UNITED STATES PATENT AND TRADEMARK OFFICE

APPLICATION NO.	FILING DATE	FIRST NAMED INVENTOR	ATTORNEY DOCKET NO.	CONFIRMATION NO.
10/673,053	09/26/2003	Rainer Bruchhaus	14580-031001	1239
20985	7590	06/22/2005	EXAMINER	
FISH & RICHARDSON, PC 12390 EL CAMINO REAL SAN DIEGO, CA 92130-2081			KIM, SU C	
			ART UNIT	PAPER NUMBER
			2823

Office Action Summary

FIG. 18

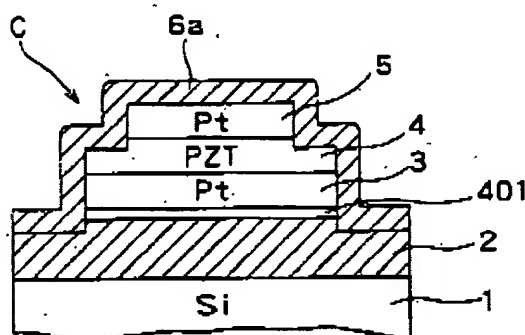
Kanaya discloses a method of forming a ferroelectric capacitor comprising forming a crystalline PZT layer as claimed. **See all the FIGS** where Kanaya teaches the following limitations

1. Pertaining to claim1, Kanaya discloses a method of forming a ferroelectric capacitor comprising forming a crystalline PZT layer by a process including the steps of:

depositing a layer of amorphous ferroelectric material **4** over a layer of a first material **3**;

etching the ferroelectric layer to form isolated ferroelectric elements (**See Fig 1 & 2, column 1 Paragraph [0018] ,please note briefly explain about etching process) ;**

providing a layer of a second material **5 & 6** on at least the side surfaces of the ferroelectric elements; and

the second material **5 & 6** promoting crystallization of the ferroelectric material to a higher degree than the first material **3**;

6. Pertaining to claim 6, Kanaya disclose a method according to claim 1 further including depositing electrode elements of conductive material **5 & 3** between the ferroelectric elements.

7. Pertaining to claim 8, Kanaya discloses a method according to claim 1 in which the ferroelectric material is PZT **4**.
